MEMORANDUM

To: Salt Lake City Planning Commission
From: Kelsey Lindquist, Planning Manager
Date: September 27, 2023
Re: Pacific Yard Planned Development Modification

PROPERTY ADDRESS: 443 W 700 S (Approximately)
PARCEL IDS: 15-12-129-016-0000
MASTER PLAN: Downtown Plan
ZONING DISTRICT: General Commercial (CG)
PETITION: PLNPCM2021-00822

REQUEST: Urban Alfandre is seeking a modification to the approved Planned Development for Pacific Yard. Pacific Yard previously received Planned Development and Design Review approvals from the Planning Commission on March 23, 2022. The modification includes reducing the size of the approved park strip and landscaping square footage along 400 W, in order to accommodate on street parallel parking. This change is required by ordinance to be reviewed by the Planning Commission as only minor modifications can be approved administratively. This property is located in the CG (General Commercial) zoning district.

MODIFIED PLAN:

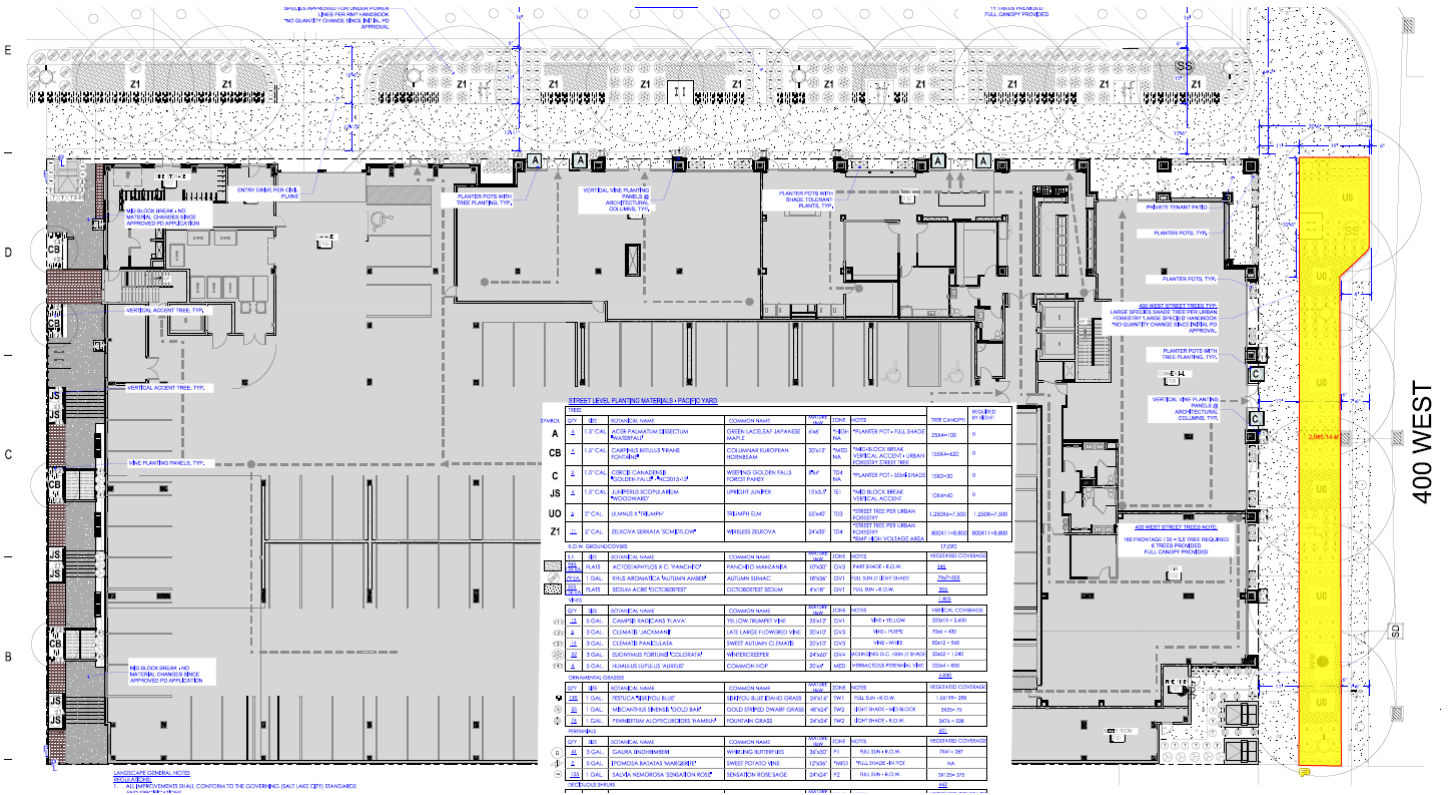
The applicant is requesting modifications to the approved design that are required by ordinance to be reviewed by the Planning Commission. The proposed modification to the approved design includes substantial changes to the 400 W right-of-way. The project was approved with a 21'5" wide park strip and a 13'10" wide sidewalk along 400 W. The enhanced park strip was to offset the potential impact of the additional height to the building. The applicant is seeking to reduce the park strip to 11' and the sidewalk to 11'. This is approximately a 1,308 square footage reduction in landscaping. It is important to note that the number of proposed street trees has not been reduced with this modification. The reduced landscaping area and sidewalk are to accommodate parallel parking along 400 W. The applicant is seeking to achieve the proposed parallel parking along 400 W to support the proposed ground floor commercial uses.

The area highlighted in yellow shows the modification to accommodate the proposed parallel parking.

LANDSCAPE PLANTING PLAN

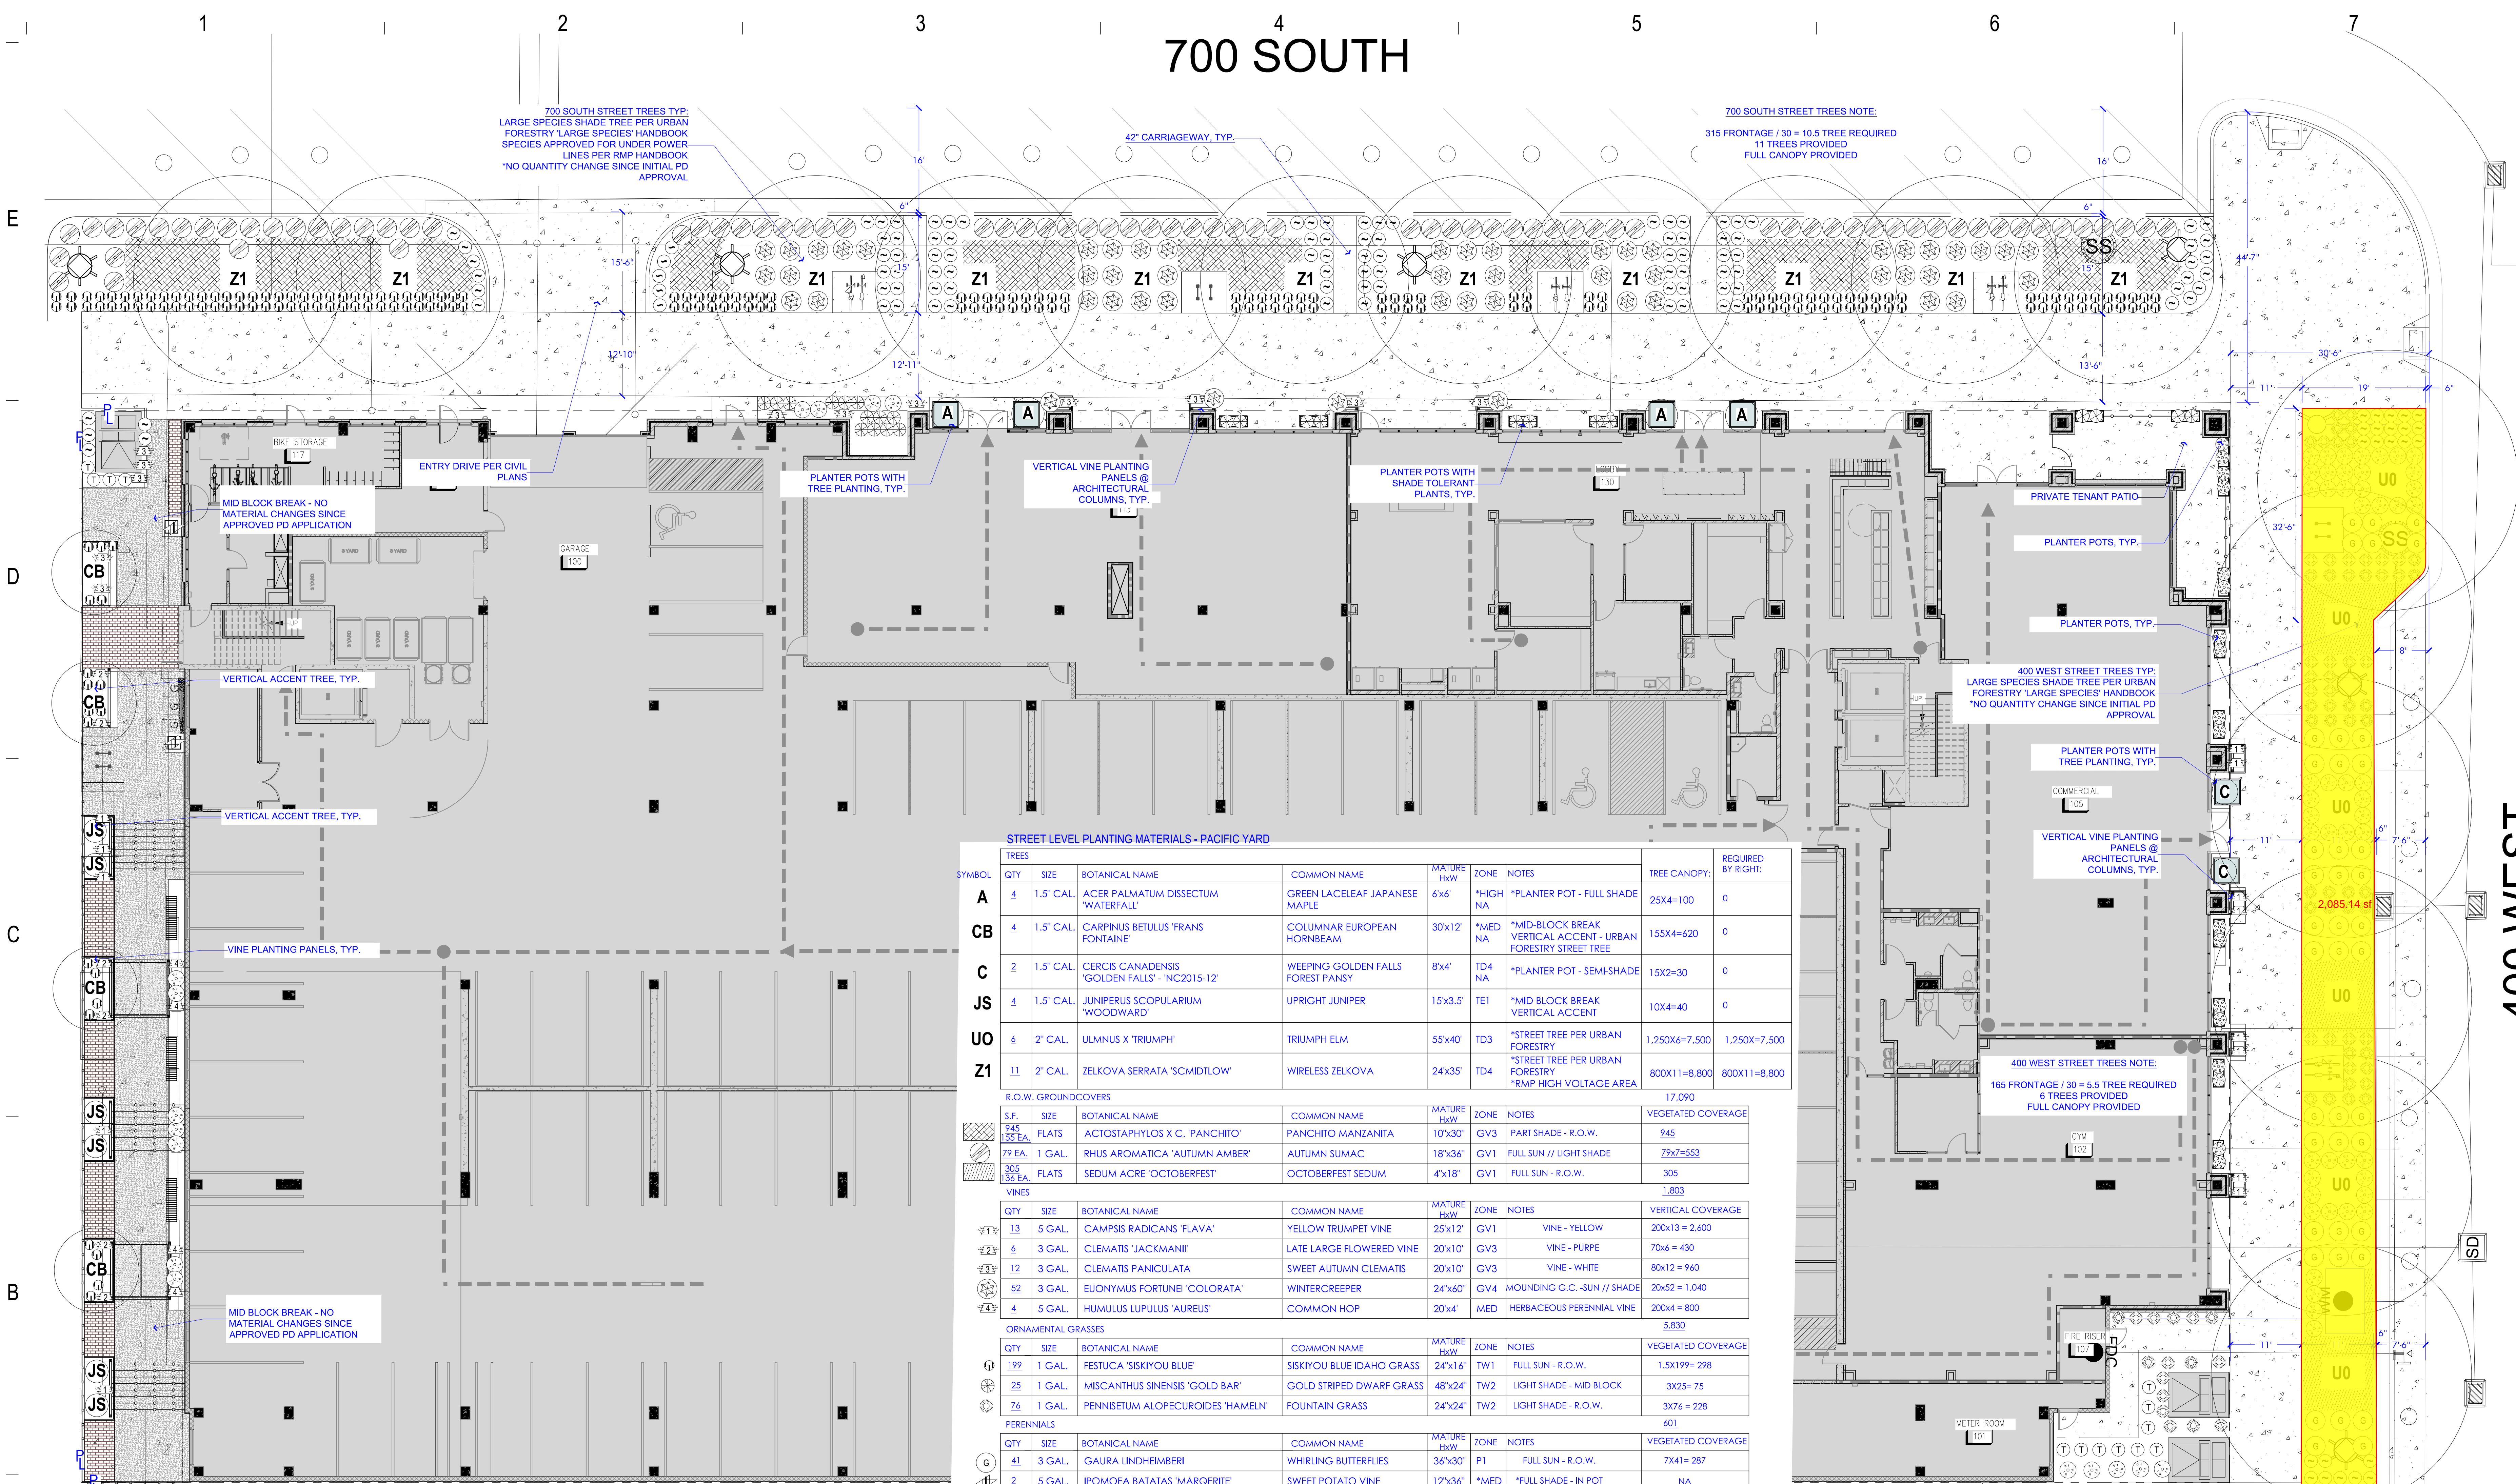
ROW LANDSCAPING @ 400 WEST NO SUBSTANTIAL DIFFERENCE IN AREA - REDUCTION IN CONCRETE WALKWAY WIDTH PER CIVIL PLANS

NO REDUCTION IN R.O.W. TREE PLANTING - MORE TREES PROVIDED THAN REQUIRED USING LARGE TREE SPECIES APPROPRIATE FOR URBAN CONDITIONS

MINOR ADJUSTMENTS DUE TO ARCHITECTURAL CHANGES - NO MATERIAL CHANGES, CHANGES ARE TO MAINTAIN DESIGN INTENT SUCH AS LINING UP PLANTS TO ARCHITECTURAL COLUMNS AND ENSURING TREE CANOPIES PROVIDE ADEQUATE SHADE
